Below are the ACME comments on the Phase II Sediment Sampling Addendum to the Final Phase I Field Sampling Plan for Groundwater, Surface Water, and Sediment for the Santa Susana Field Laboratory (SSFL), Ventura County, California.

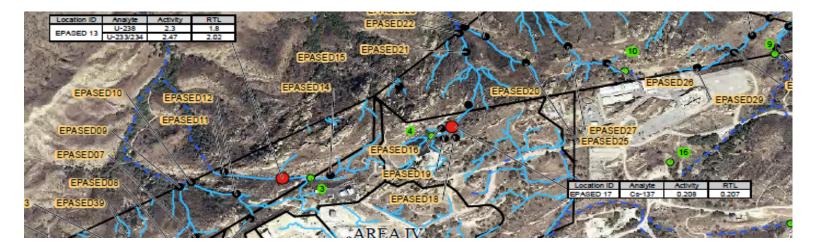
The below photo indicates with red dots, above Radiological Trigger Level readings. These are down stream from the Los Angeles Regional Water Quality Control Board (RWQCB), National Pollutant Discharge Elimination System (NPDES) permit outfalls 3 and 4 (Green dot with 3 and 4, below photo) that are tributaries to the Arroyo Simi through the American Jewish University's Brandeis-Bardin Campus. These radionuclides need to be addressed with the RWQCB with the possibility of relocating these outfalls into the Northern Buffer Zone.
